Service Bulletin

Subject: Clamshell Grill ATX Conduit and Access Hatch Change

Brand/Product: Next Gen Grills

Date: 5th June 2020

Old Hatch and conduit up to 19041001XXXX

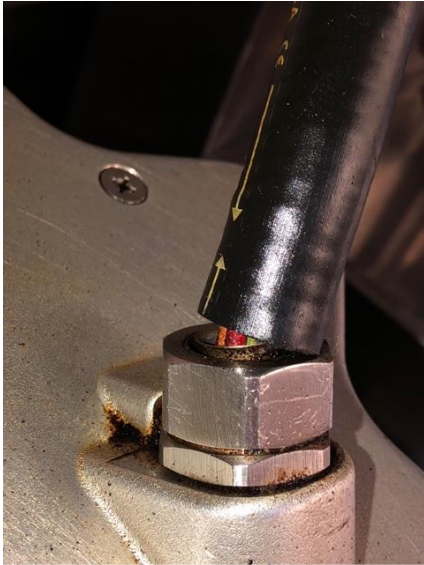
Old Conduit design (Installed on units up to and including April 2019 Serial 19041001XXXXX)

Use a 45-degree angle fitting to connect to the top of the platen cowl access hatch. This is then secured by a lock nut on the other side of the cowl cover.

New Conduit design (Installed on units from May 2019 Serial 19051001XXXXX)

The new ATX Conduit has a single straight nut. The nut will screw directly to the cowl access hatch. The new cowl access hatch is designed so that it has a 20-degree raised threaded section moulded into the casting for allowing tightening to the conduit nut. This reduces the number of potential entry points of any liquid to the platen cowl and reduces the entry angle of the conduit. It also relieves some stress at the joint. The new conduit should be used on grills built from 19051001XXXXX, it will also be the fitting needed if you are replacing the grill cowl or platen assembly. If you are ordering a platen assembly for a unit Pre 19051001XXXXX, order it with the conduit to avoid any compatibility issues.

When you receive a new design conduit (CK4603291), you will also receive a separate cold shrink sleeve, this will need to be fitted once the conduit has been fitted into the access hatch. The cold shrink sleeve will allow you to tighten the conduit nut to the access the hatch cover. This would not be possible if the cold shrink is pre-fitted.
